PIC18F04/05/14/15Q41 Silicon Errata and Data Sheet Clarifications

PIC18F04/05/14/15Q41

Introduction

1.6.1 UART TXDE Signal May Go Low Before the STOP Bit Has Been Entirely Transmitted

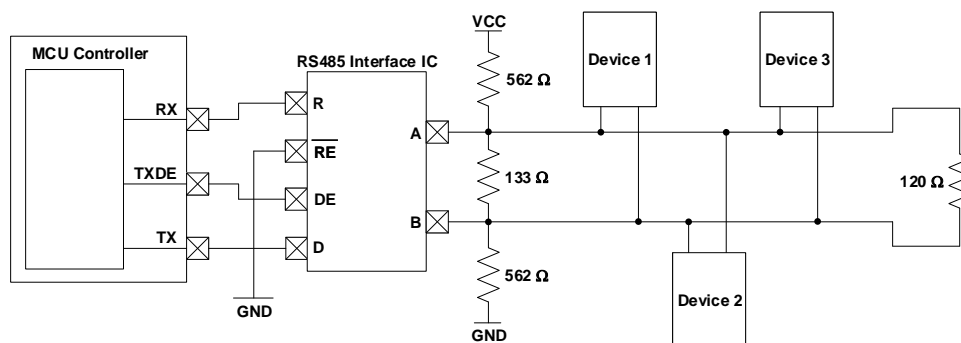
The UART Transmit Drive Enable (TXDE) signal could potentially transition into a low state before the UART STOP bit has been entirely transmitted due to the effects of parasitic capacitance on the TX line. In some applications, this could result in communication being prematurely terminated due to the TXDE signal going low before the STOP bit has had enough time to settle.

To ensure that the STOP bit settles into its final logic state before the TXDE signal transitions low, a biasing circuit can be implemented. A biasing circuit allows the TX line to either be driven high or low, rather than being left in a floating tri-state mode where prolonged rise or fall times could lead to communication being disrupted. This bias circuit should only be implemented on one end of the serial bus, and a termination resistor should be used on the other end. The figure below shows an example of a bias circuit that can be used to achieve this.

Please note that the resistor values used in this circuit are recommendations and that the actual resistor values required may vary based on the application.
